SUBJECT: Performance Bond [1308 and 1310 33rd Street] (PW#06-031-DEV)

Memo

Subject: 1308 and 1310 33rd Street – Randy Click (PW#06-031-DEV)

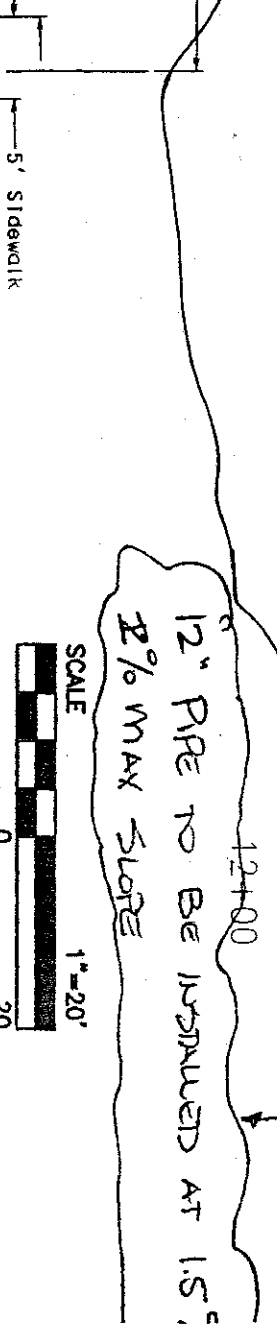
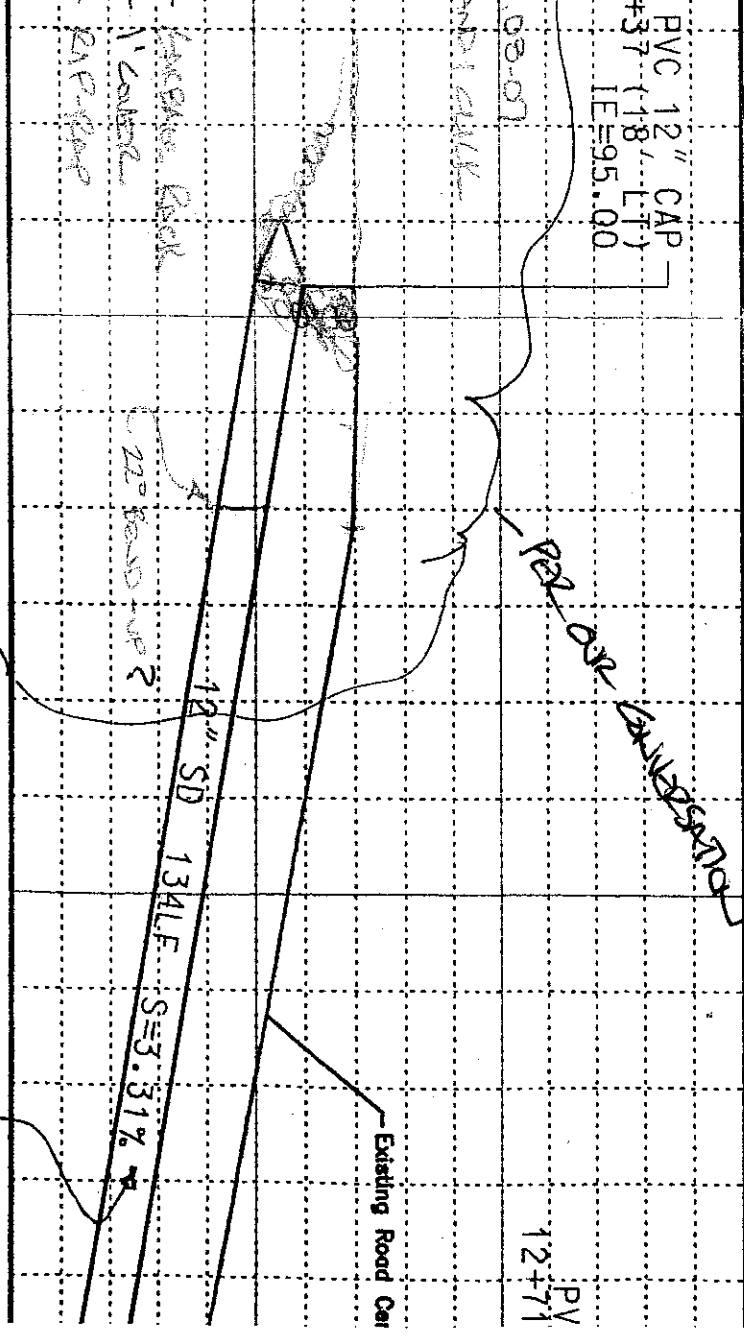
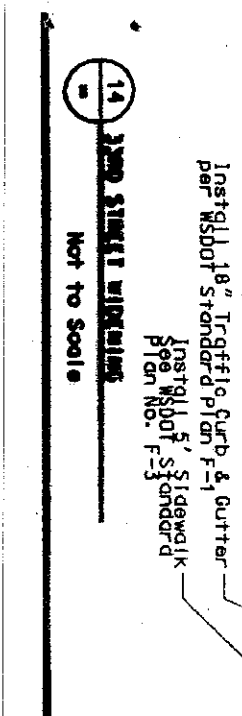
The drainage condition that needs to be corrected is:

1. Exposing the end of the 12-inch culvert.
2. Extending the 12-inch culvert to the west side of the neighbors driveway and
3. Installing rip-rap, garbage rack.
4. Provide enough cover over the extended 12-inch culvert to allow the swale to drain to the culvert.
5. See attached 11x17 plans.

NOTE:
BEST CONSTRUCTION - EXISTING SYMBLUE IS BUILT CURB GRADE. NEED TO CORRECT DRAINAGE

12" SD SHALL EXTEND FROM PROPERTY LINE TO FURTHEST WORKING PROPERTY LINE OF 1308

12" PIPE TO BE INSTALLED AT 1.5% SLOPE
2% MAX SLOPE
